Our Reference: PDA/2023/5733
 CS Portal Reference: N/A
 Contact Officer: Sophie Spencer
 Contact: 07 4688 6808
 Email: development@tr.qld.gov.au

INFORMATION REQUEST

Development Application for: Material Change of Use - Shopping Centre and Multiple Dwelling (56 Units)
Location: 1A-3 Neil Street, TOOWOOMBA CITY QLD 4350
Property Description: Lot 3 AG208, Lots 1 to 3 RP16672, Emt D SP193240, Lots 26 to 28 RP16674, Emt C SP193240, Lot 2 RP129701, Lot 1 RP151665 & Lot 5 RP16677
Relevant Development Scheme: *Toowoomba Railway Parklands Priority Development Area (PDA) Development Scheme*

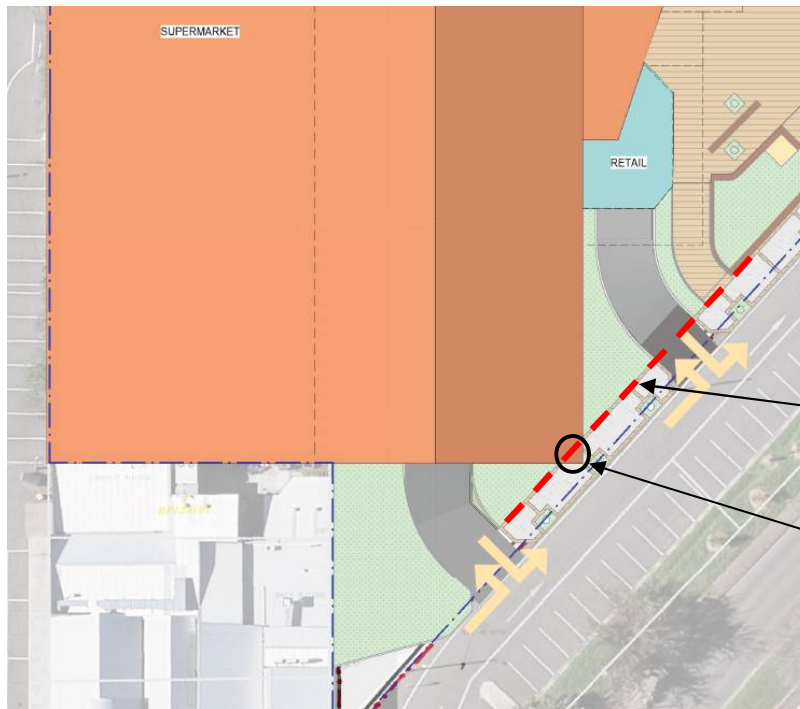
5.1	<p>Issue:</p> <p><u>Supermarket Roof Line</u></p> <p>The Roof Plan shows the supermarket roof line over the proposed Chalk Lane footpath. Council intends to require the dedication of the pathway as road reserve, and as such the roof would extend into the road reserve (over public footpath) -see image below. As the roof does not act as an awning, it must be contained within the site boundaries including road dedication.</p> <p>Furthermore, the extent of the supermarket roof is unclear particularly whether the roof area is larger than the supermarket floor area. Submitted elevations and perspectives do not appear to show roof eaves/overhanging beyond the supermarket floor area. However, the Short Section (Page 31) shows a roof overhanging the eastern (Neil Street) and western facades.</p> <p>Elevations show perforated metal on the supermarket building facing Chalk Lane (used for signage) and also near Neil Street. This appears to extend beyond the roof line and building line and is not shown on the roof plan or floor plans.</p> <p><u>Awnings</u></p> <p>The heights and depths of the awnings have not been shown on submitted plans. Awnings must be dimensioned and positioned to provide effective shelter for pedestrians using public footpaths (Neil Street and Chalk Lane). Council's preference is for awnings to cover the full width of pedestrian pathways fronting the site wherever possible. Awnings should be horizontally setback from the kerb to avoid conflict with street trees and vehicles at the kerbline. Refer to Item 4.1 and</p>

4.2 about smaller trees on Chalk Lane and tree cells in kerb builds out in Neil Street.

Red dashed line- Likely road reserve widening

Roof within road reserve (over pathway)

- (a) The extent of the roof line contained within the site boundaries which considers the intended road dedication;
- (b) The perforated metal extensions to the supermarket; and
- (c) The dimensions (height above pedestrian level and depth) of awnings.

05 / Plans and Sections

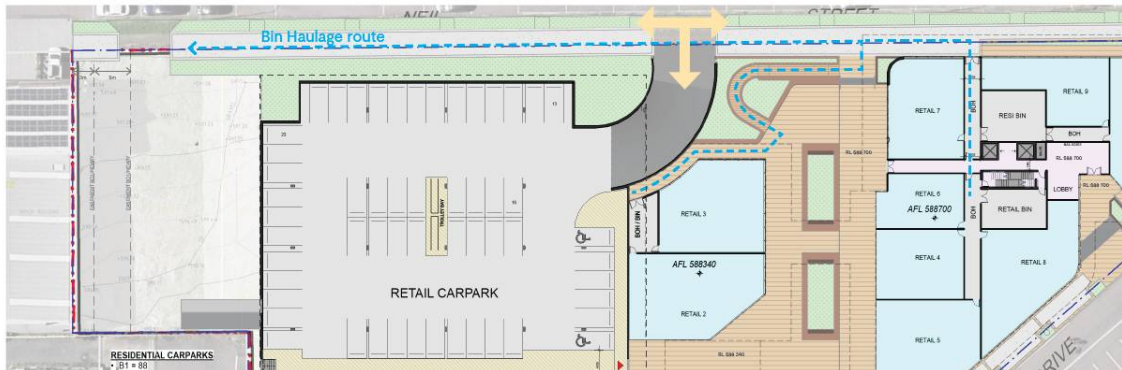
The submitted material shows a bin haulage route for Retail Shops 1-10 and the 56 dwellings in the residential tower along the public footpath on Neil Street (approximately 110m) to the loading dock at the rear of the supermarket, as per the image below.

- Provides an alternative bin haulage route contained within the site and separated from public footpaths;
Advice Note: The applicant is requested to consider a more direct and on-site bin haulage route from the residential tower through the supermarket carpark. An industrial lift would be required to shift bins to the loading dock for refuse collection.
- Confirmation the bin haulage route for Retail Shops 1-3 is of sufficient dimensions and grade for a 1100L bin and tug, ensuring the ramp is designed to ensure the waste bin and tug can turn around the tight corners; and
- Consistently shows the bin haulage route.

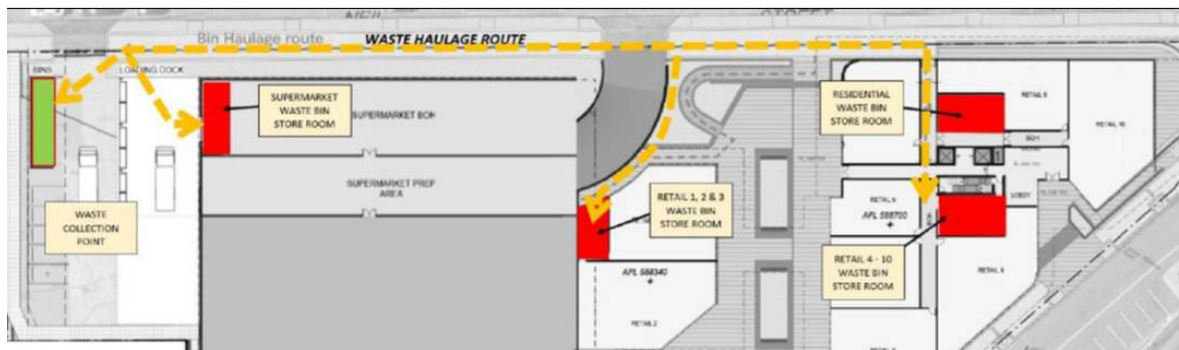
- It appears that up to 30 bin movements per week (for retail stores and dwellings) will occur on the proposed bin haulage route. This is an unacceptable risk to public safety on a public footpath. An alternative path contained within the subject site and separate to public footpaths, must be provided to address safety.
- It is unclear if a 1100L bin and tug servicing Retail Shops 1-3 can fit through the meandering pathways and grades of the ramps shown.
- The bin haulage route shown in the Waste Management Plan does not accurately show the route from Retail Shops 1-3, as per the image below.
